MINIMUM INSPECTION PROCEDURAL GUIDELINES
FOR BUILDING ELECTRICAL RECERTIFICATION

a. Name on Title: Village at Dadeland Condominiums (J)

b. Street Address: 7600 SW 82nd St. Miami, Florida 33143

Photo #7:

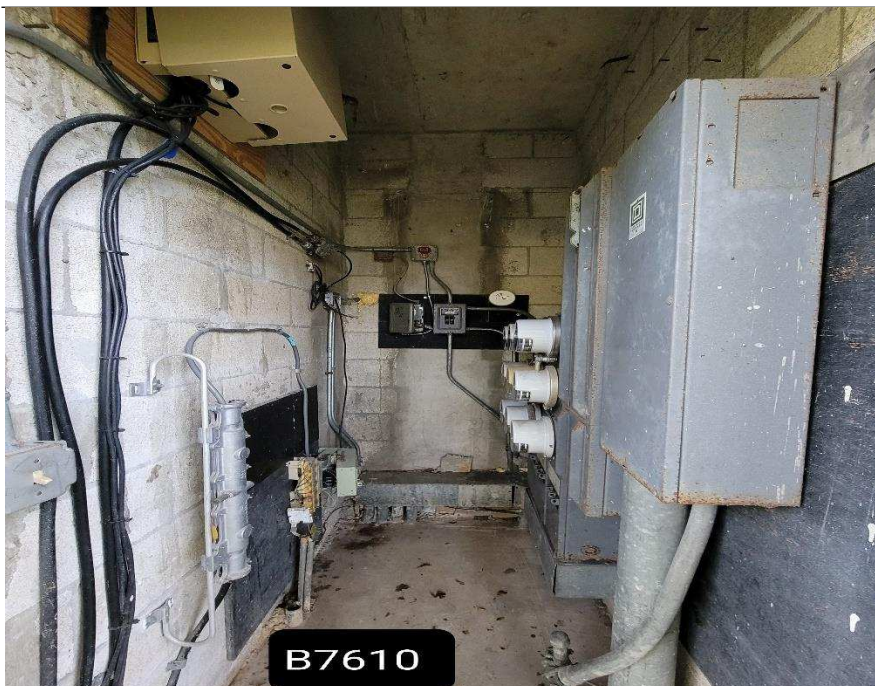
The top wearing surface of the catwalks are stained or weathered and require maintenance.

Photo #3:

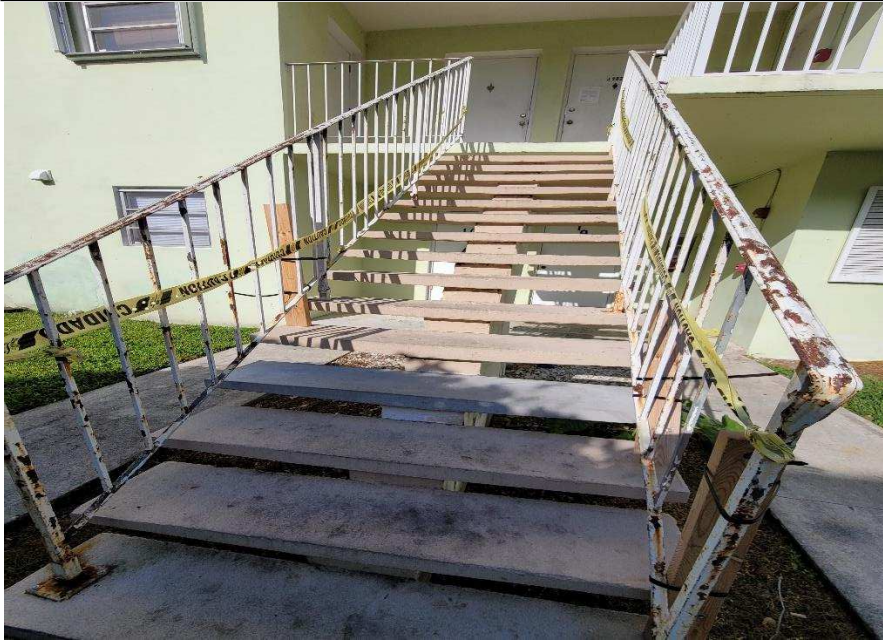
Replacement of the steel picket rails is necessary due to the extent of corrosion at the base of the rail posts.

Photo #5:

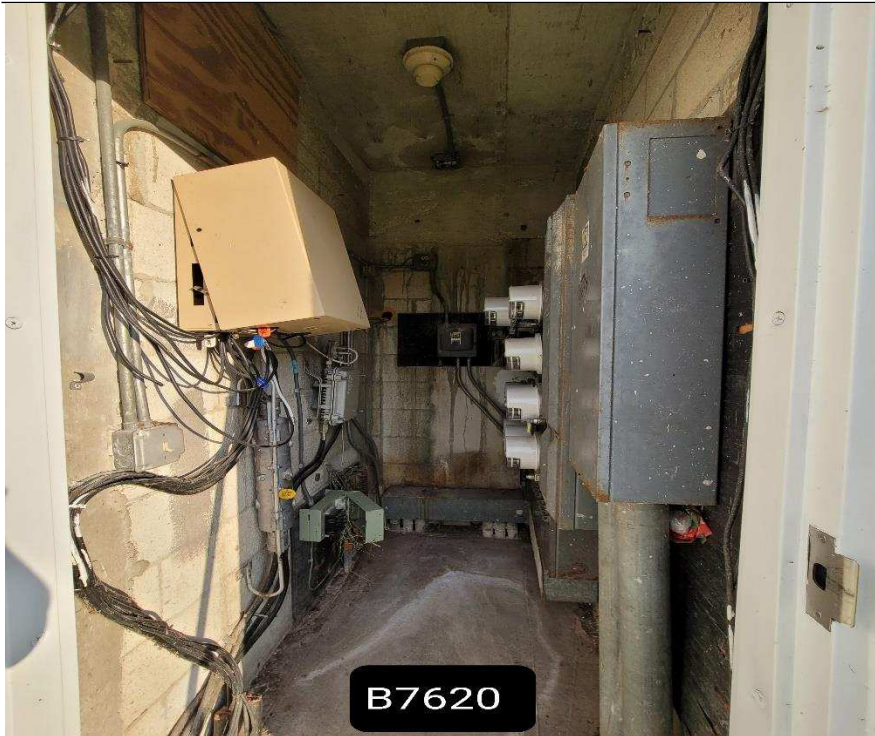
The mechanical room was observed to be in good condition. Wall/ceiling penetration should be sealed.
